CITY OF CODY
PLANNING, ZONING AND ADJUSTMENT BOARD
WEDNESDAY, NOVEMBER 12, 2014
CITY HALL COUNCIL CHAMBERS

**CITY OF CODY
PLANNING, ZONING AND ADJUSTMENT BOARD
STAFF REPORT**

**CITY OF CODY
PLANNING, ZONING AND ADJUSTMENT BOARD
STAFF REPORT**

CITY OF CODY PLANNING, ZONING AND ADJUSTMENT BOARD STAFF REPORT

Site Plan
Coe Residence
1050 Park Ave.

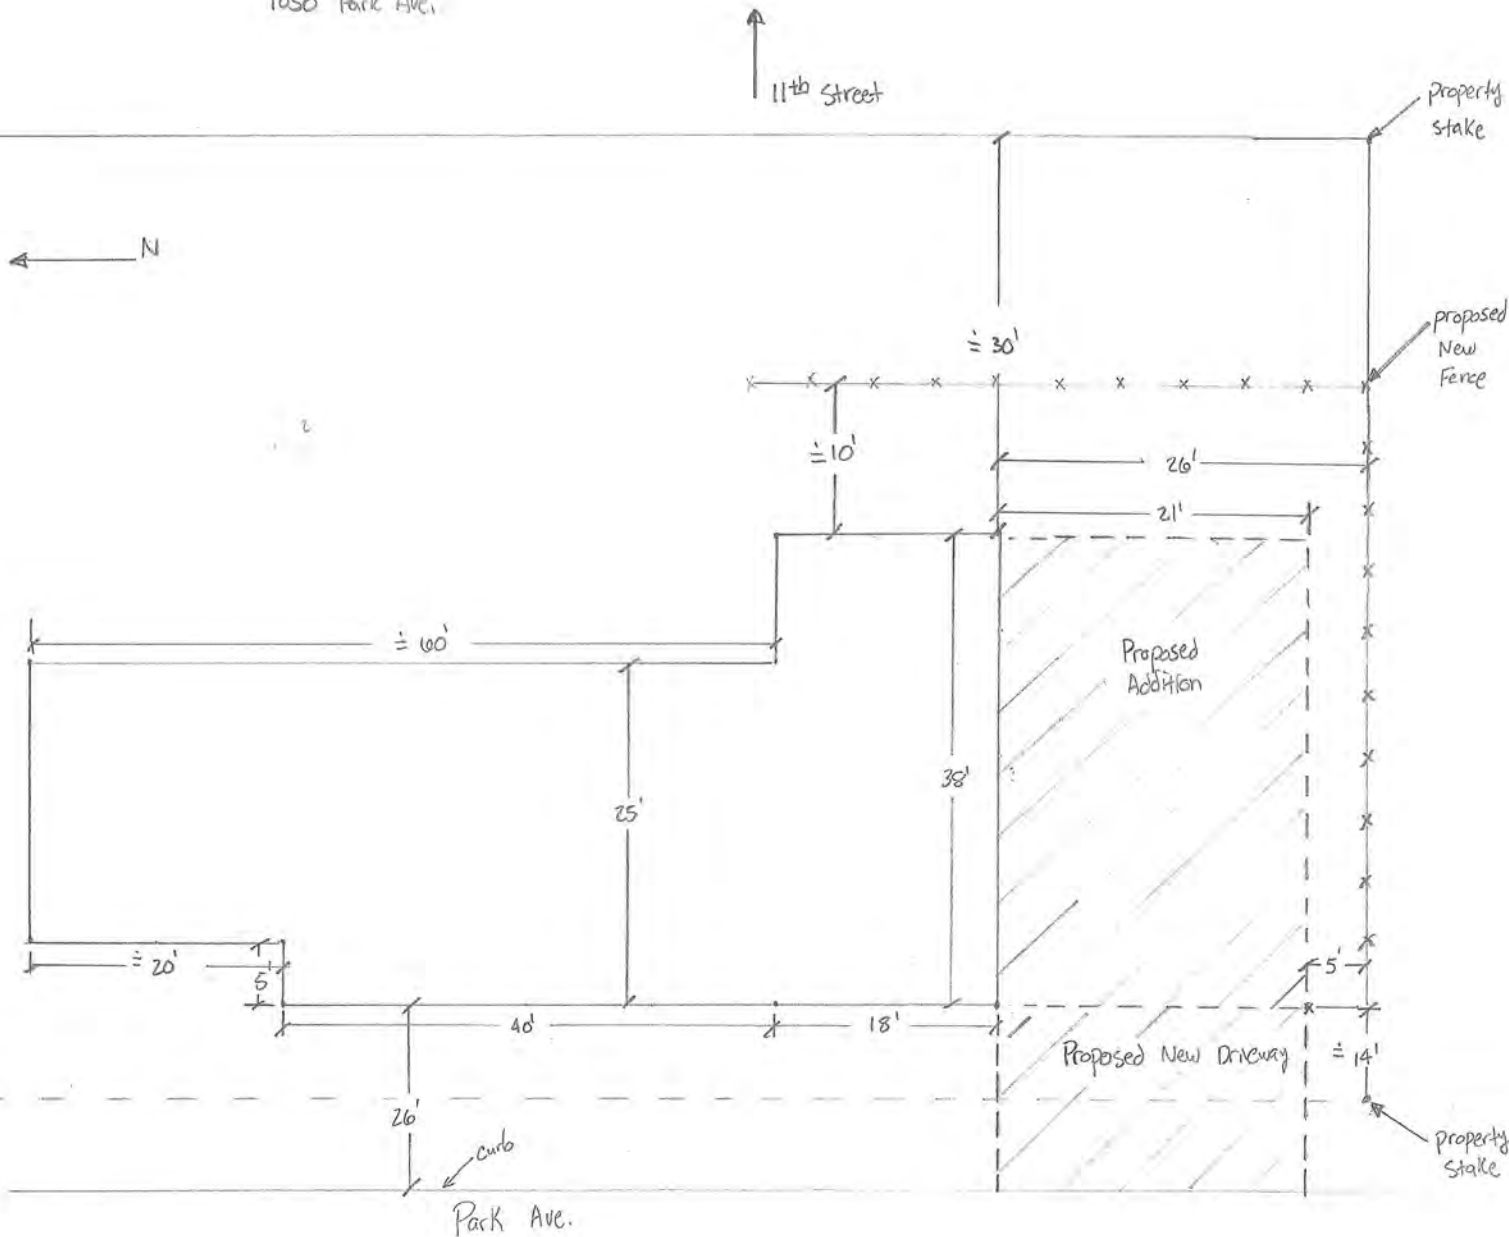
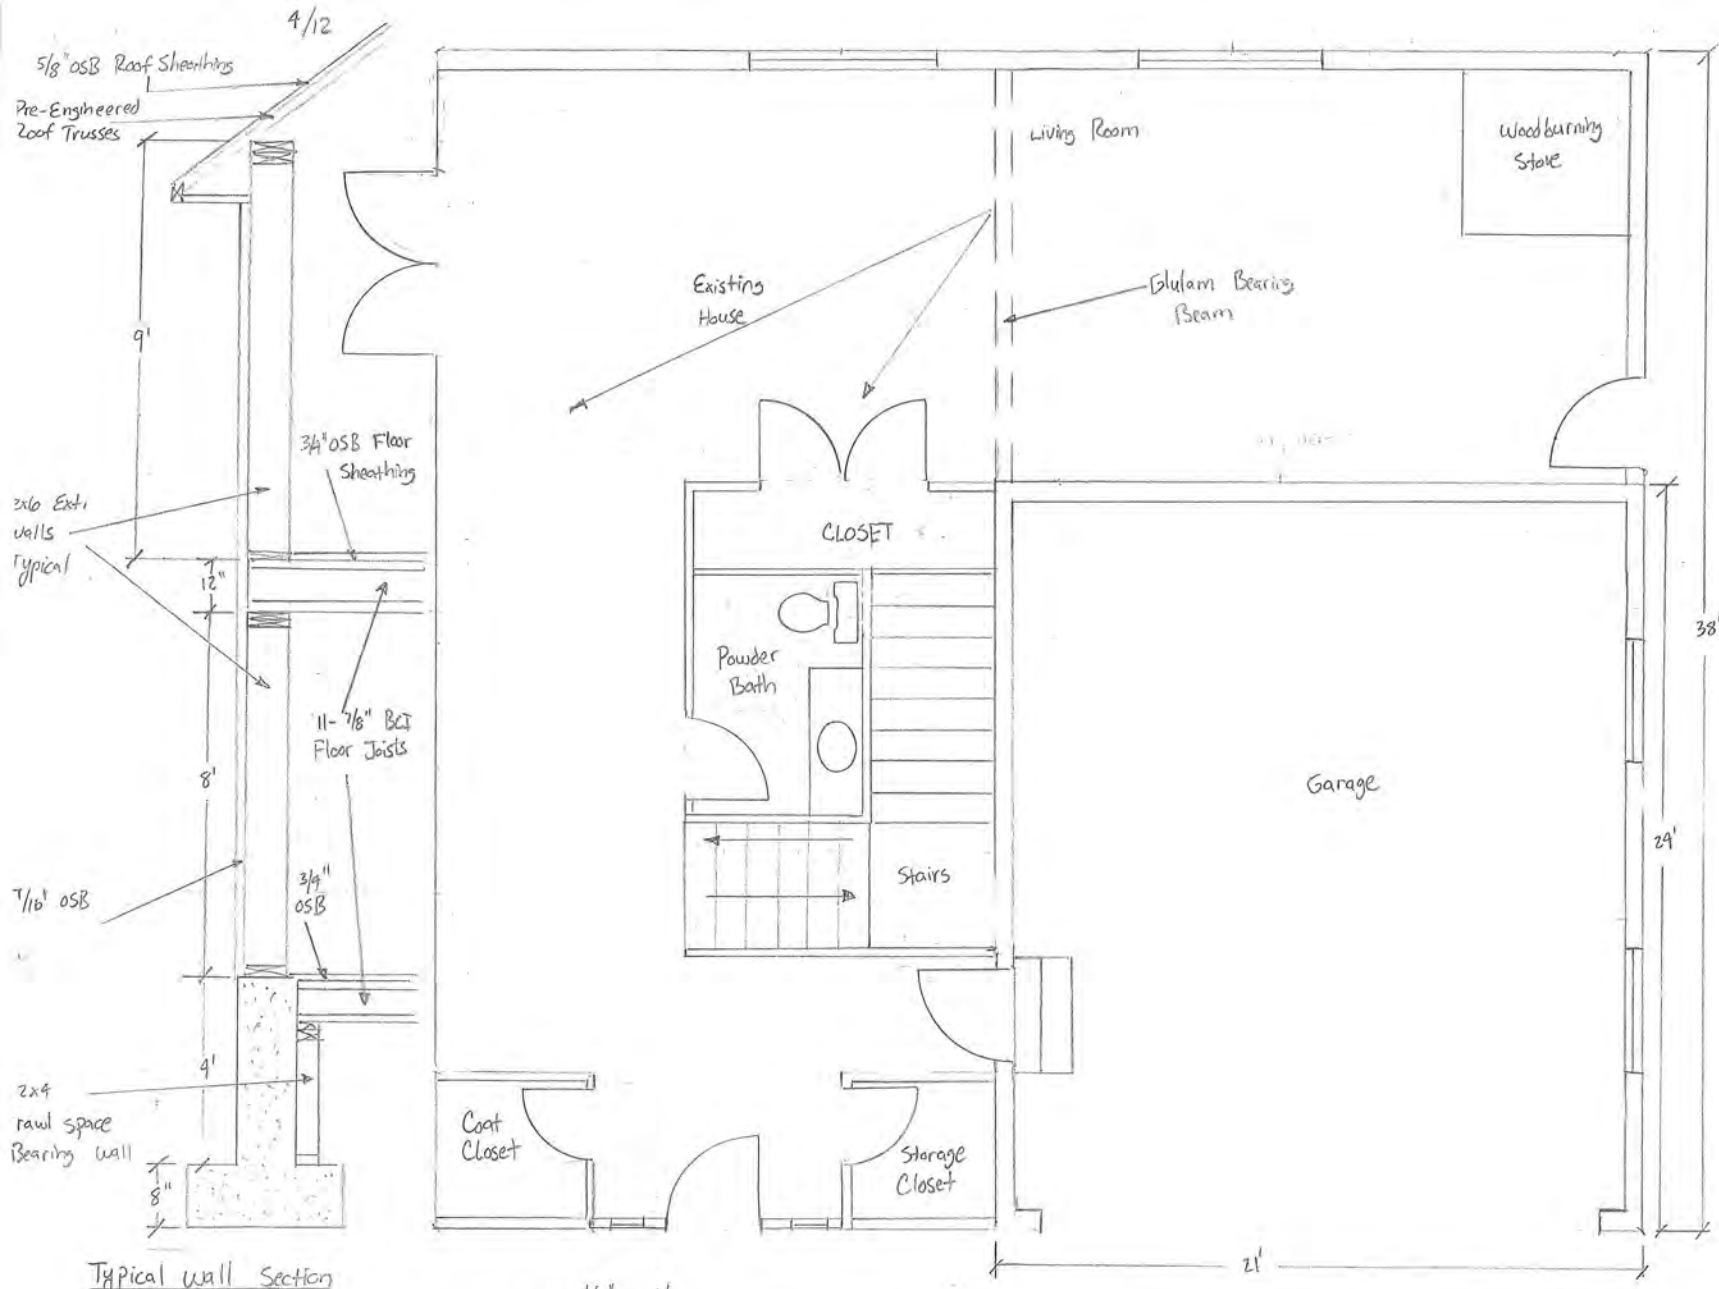
Staff Comment: The addition is proposed to be in alignment with the front and back of the existing house. In determining whether it is the minimum deviation or not, staff looked at whether the applicant could cut down the room sizes, or push the addition back. Pushing the addition back would eliminate what little back yard exists behind the addition, and is very limited by the hillside behind the house. Cutting down room size is not really an option, as the garage is proposed at a standard depth of 24 feet, and the living room behind is proposed at 13 ½ feet wide. Meeting the setback would effectively require complete removal of a room from the main floor plans.

Staff Comment: No other feasible options have been identified that would achieve the requested result. Relocating the addition to the other side of the house would not help, as the same area limitations and setbacks exist. Relocating the addition to the back of the house would use up the back yard and likely conflict with required egress windows.

Staff Comment: The future land use map designation for this area is "low-density residential", which is consistent with the continued residential use of the property. There are no identified goals specific to the setback situation, other than general statements such as "protect the existing character in stable residential areas" which fits into items 'a' and 'b' above. It is also noted that the street width is not planned to be widened and the addition will be approximately 26 feet behind the curb line. In other words, it will have the appearance of having a greater front setback than it technically has.

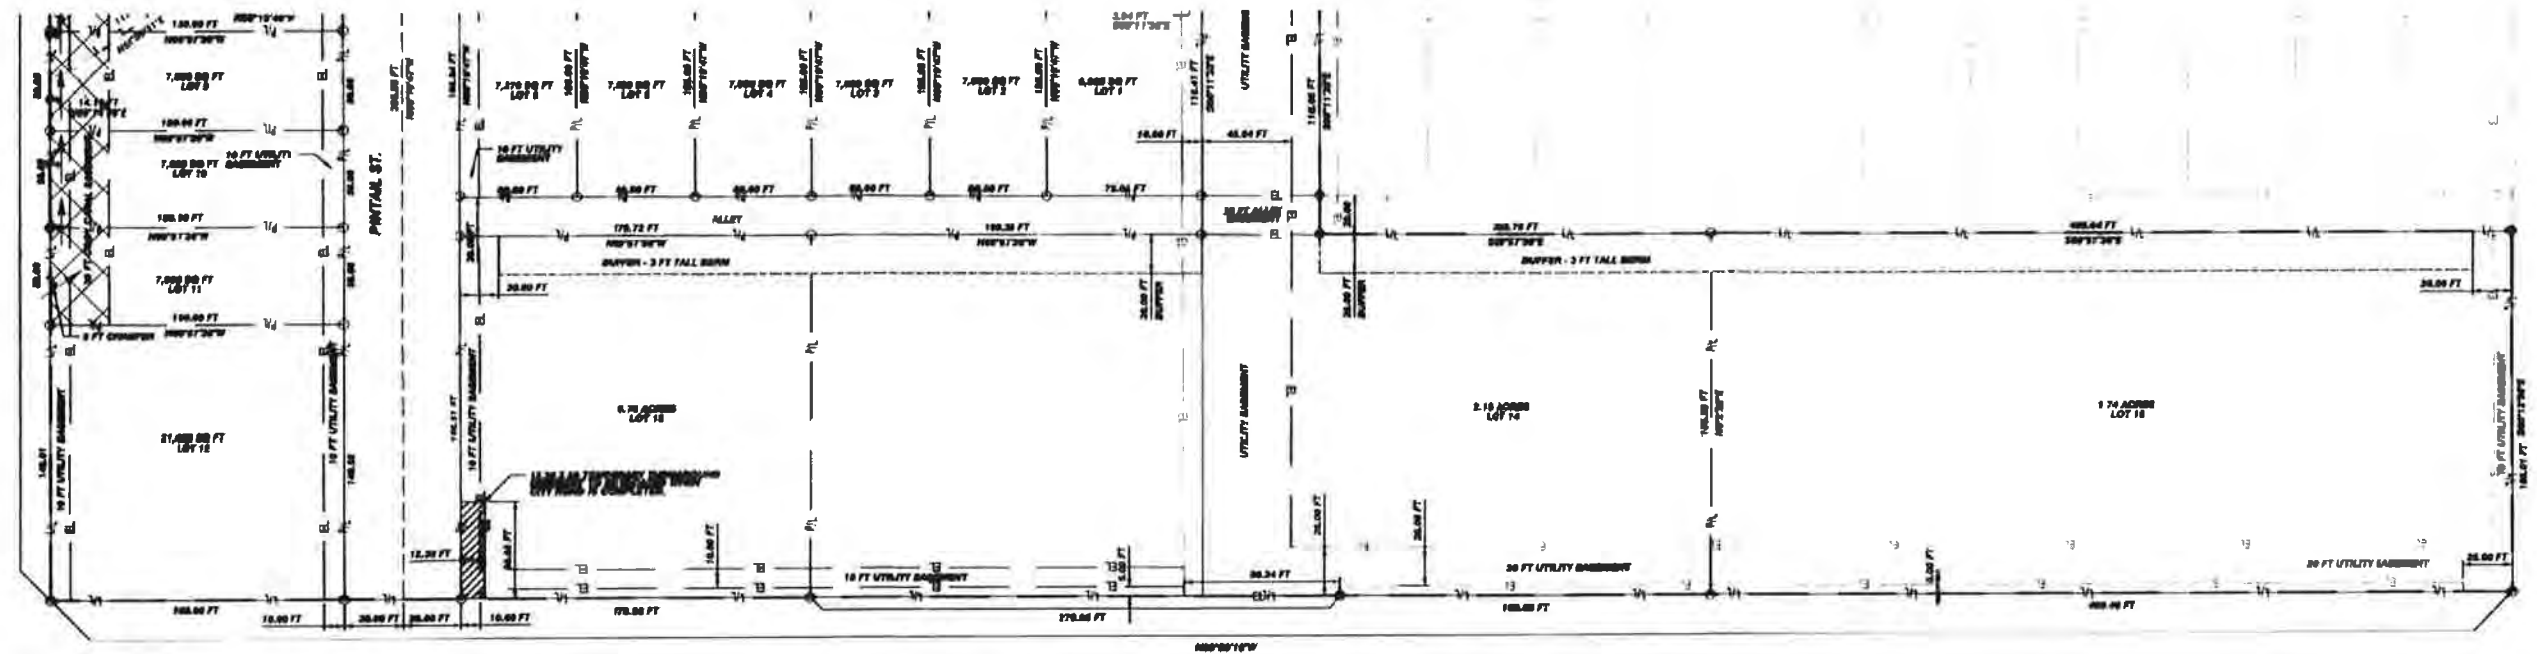
Due to the lack of comments received from the adjacent property owners nearest the buffer, and without the benefit of the public hearing, staff is not providing a

- 1) Denial of the request.
- 2) Modification of the buffer/berm requirement by reducing the required width, perhaps in consideration of installing trees in the buffer area.
- 3) Approval to remove the berm across Lot 15, but require that the buffer remain in place for any buildings, and for any open storage taller than six(?) feet in height.
- 4) Approval to remove the berm and buffer limitations across Lot 15.

In the case of alternatives 2, 3, and 4 staff would recommend that the approval be conditioned on a six-foot tall solid fence being maintained along the north property line, and a limitation that the waiver of the berm and buffer requirement only be in effect so long as the site is utilized for mini-storage with no buildings taller than 9'2". A fifth alternative would be to recommend approval to remove the berm and buffer limitation across Lot 15, with no specified restrictions. In this scenario, any buffer needed in the future would rely on the review authority and buffer requirements in place at that time, if any.
